RE: CASE #13-159SP - Approval of a Site Plan for a Multi-Family Development, Being Less than 1 Acres, Located on the Northeast Corner of North Chestnut Street and East Logan Street.

On January 14, 2014 the Planning and Zoning Commission approved the site plan for a multi-family development, which was received by the Planning Department on January 8, 2014. The approval is conditioned as follows:

01 ARCHITECTURAL SITE PLAN
 SCALE 1/16"=1'-0"

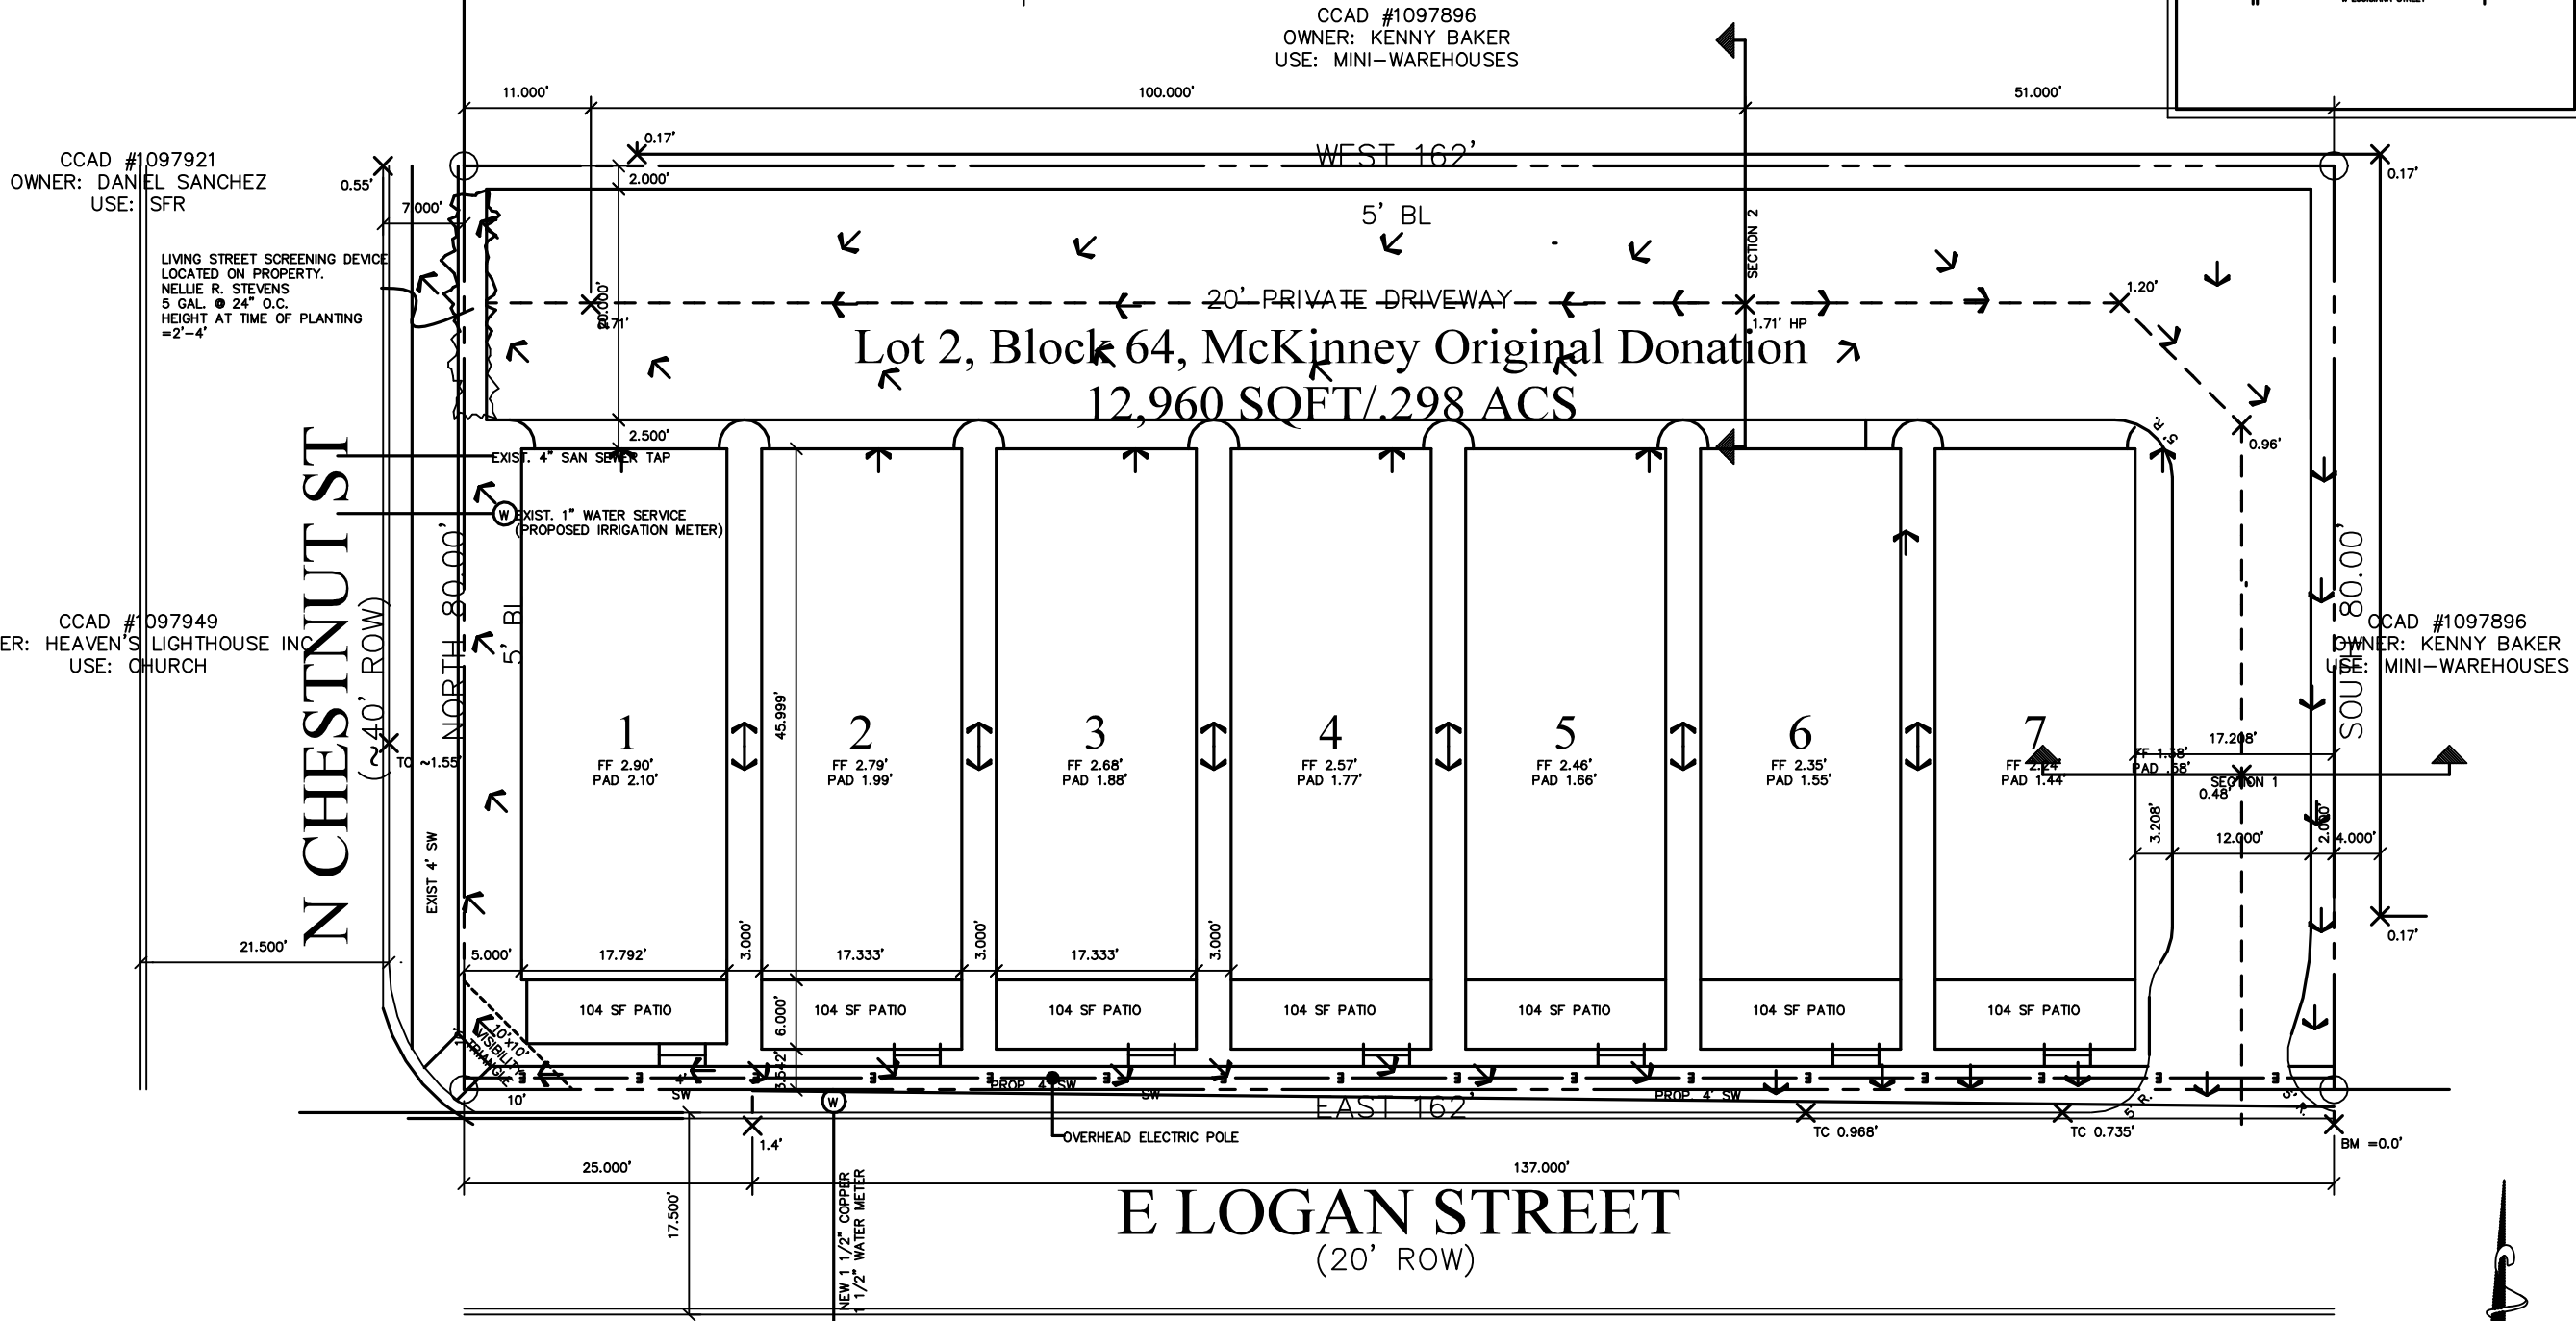
3. The applicant revise the proposed sidewalk to be ADA compliant, subject to the review and approval of the City Engineer.
4. The applicant revise the site plan to include the standard notations for sanitation containers, screening of mechanical and heating and air conditioning equipment, and lighting per Section 146-45(Site plan approval)(a)(3)(a)(18)(i.-iii.) of the Zoning Ordinance.
